SERVICE LETTER

* Supersedes Service Letter SL900-065R1, dated 15 October 2010. Changed to add washers Part Numbers (PN AN960JD616L) and (PN NAS1149D0663J).

INSTALLATION OF ENGINE GROUND STUDS

MODELS AFFECTED: MD900 helicopter serial numbers 900-00008 thru 900-000143.

Figure 1. Stack-up of Ground Studs at GS402 and GS403

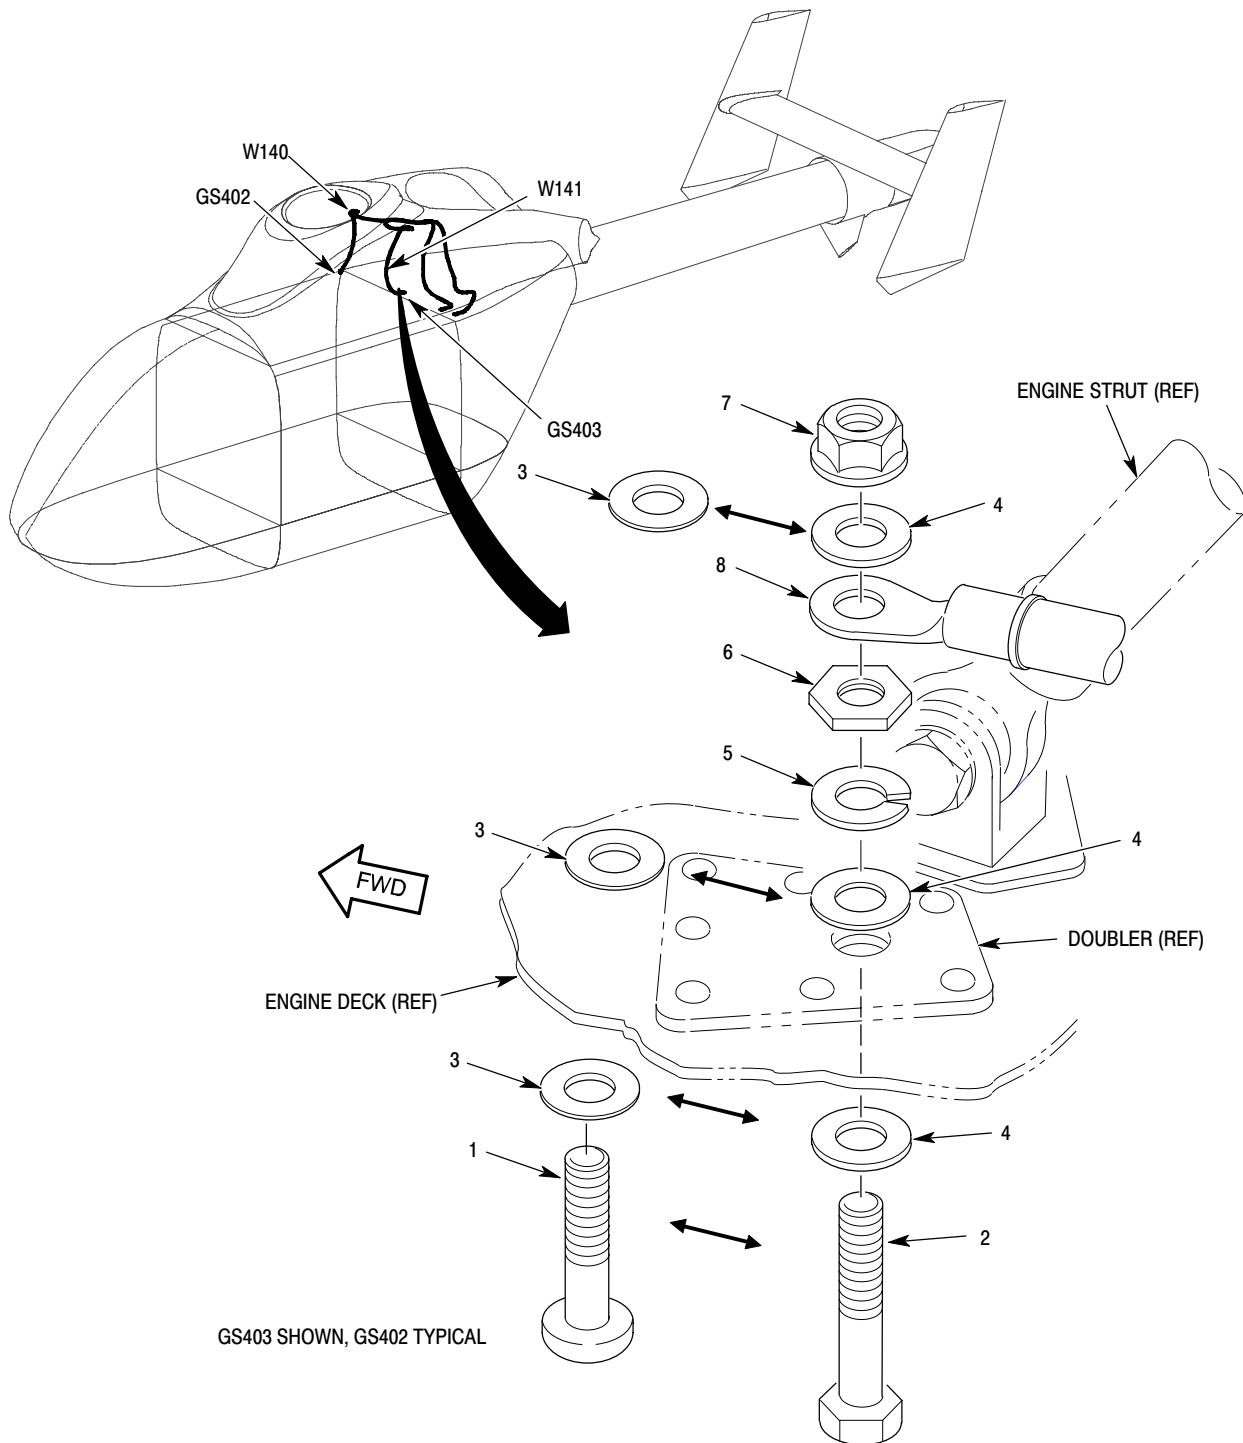
This Service Letter is issued to recommend that operators inspect starter/generator ground studs for arcing, corrosion, and looseness at the next annual inspection. This inspection is necessary to find loose ground studs, or corrosion or arcing that can cause a starter/generator problem. The ground studs are located on the engine deck: right-hand GS402 at STA 225.45 BL 23.12 and left-hand GS403 at STA 228.67 BL -5.15 (ref. Figure 1).

To decrease the possibility of incorrect torque, MDHI will no longer use NAS1635-6-16 Phillips-head screws with three AN960JD616L flat washers at each of the starter/generator grounds. AN6C7A hex-head bolts with three NAS1149D0663J flat washers will be used as alternative ground studs on Rotorcraft SN 900-000144 and subsequent. AN6C7A bolts and NAS1149D0663J washers can be purchased commercially by the operator and can be installed on all rotorcraft without modification.

NOTE: If necessary add washer. (4).

If no corrosion is found, but the grounding stud is loose, torque the ground stud to **110 in-lb (12.4 Nm)**.

NOTE: If the NAS1635-6-16 screws and AN960JD616L washers are replaced with AN6C7A bolts and NAS1149D0663J washers, you do not have to do the next or future annual inspections.
